OBJECTION TO BOWDENS SILVER AMENDED APPLICATION SSD **5765**

MARGARET CAMERON

Simulated view of realigned power lines (in red) from Wyuna, 16 August 2021

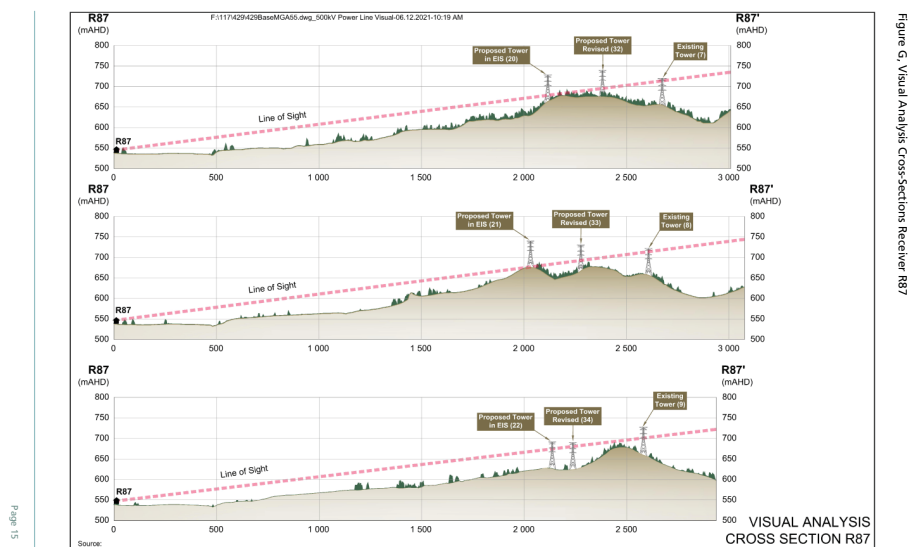
In August 2021 I made an objection to the realignment of the 500KW power lines based on an image of how I thought the power lines might look from my property (see image above at top). I requested that Bowdens correct this image if it were inaccurate. The simulation in the above image labelled *Figure G, Visual Analysis Cross-Sections Receiver R87¹* and found in the Water pipeline amendment confirmed my fears that my view will be significantly damaged. The attempt to mitigate this damage by again moving the powerlines as suggested in this latest amendment is ineffectual and quite ridiculous. As their own visual analysis shows, there is very little if no discernible change to my view from one amendment to the other.

We will go from seeing nothing to seeing something large and ugly, the composition made up of huge pylons and cleared land beneath them. I fail to see how this assessment could dismiss the issue as easily as it does, it is simply incorrect to do so.
